Addendum No. 1
04/11/2024

**Stadium Way Roadways: Repave Stadium Way,
Wilson Road to Cougar Way**
Washington State University
Pullman, WA

Project No. 2087-2024
Washington State University
Facilities Services, Capital

DWG 1-2. Sheet C-5 – Paving and Striping Plan 2

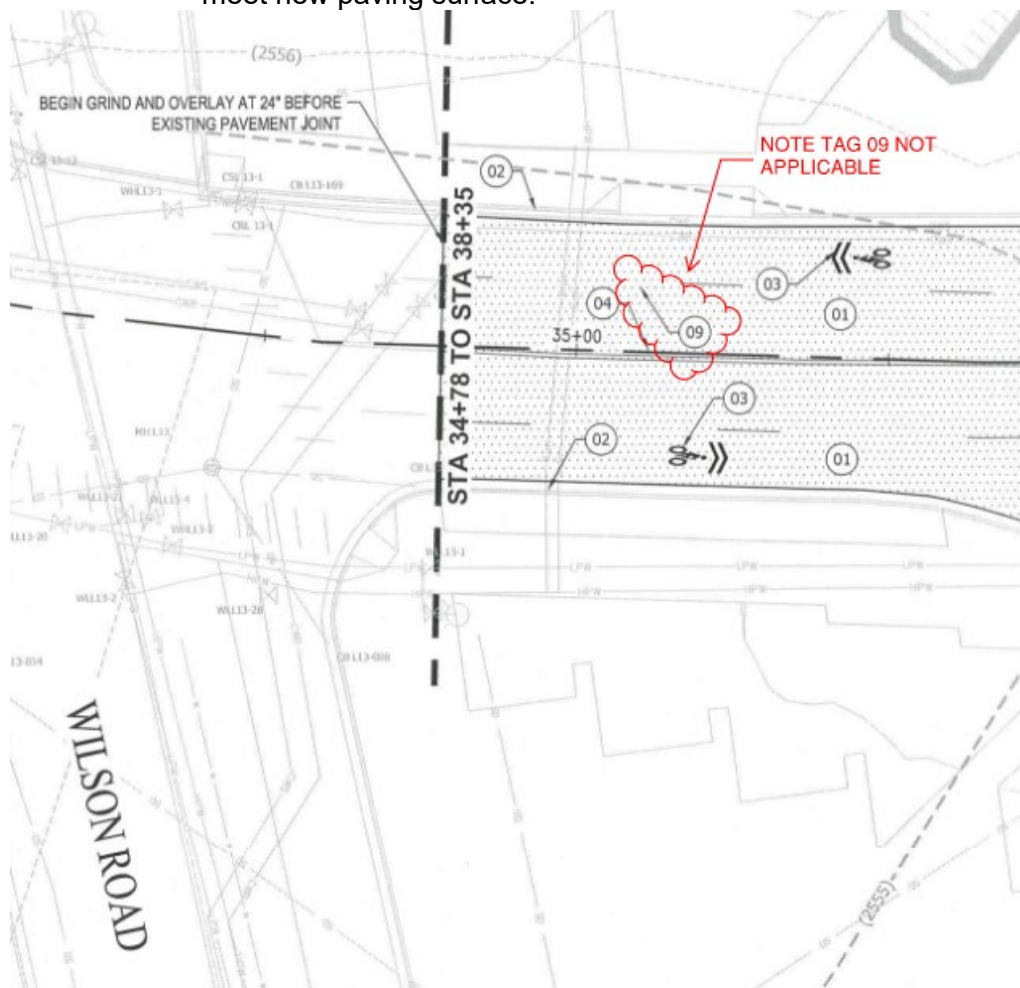
- Item 1. Tag 09 is not an applicable tag at this location. Note 09 refers to storm manholes on other drawings. There is no storm manhole at this location, there is however a Communication manhole that shall be adjusted to meet new paving surface.

DWG 1-4. Drawing C-7 – Paving and Striping Plan 5

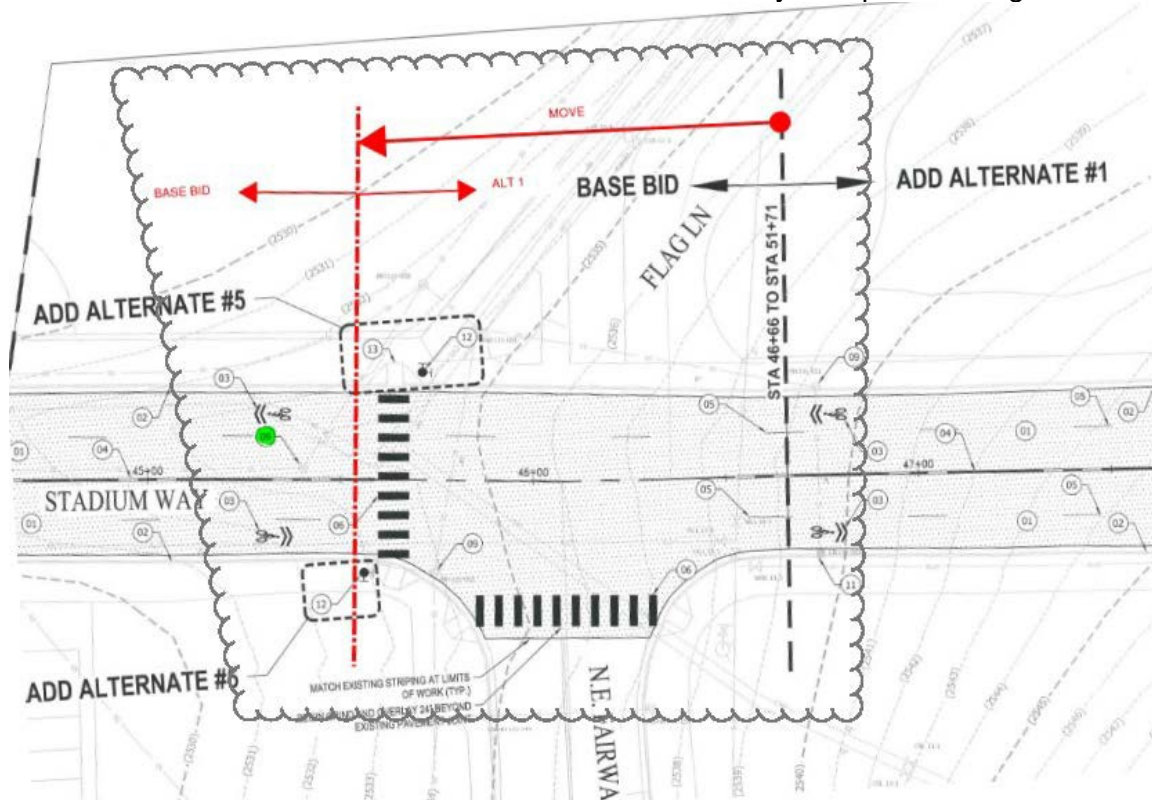
- Item 1. Revise: Base Bid and Alternate #1 Boundary Line per the image below:
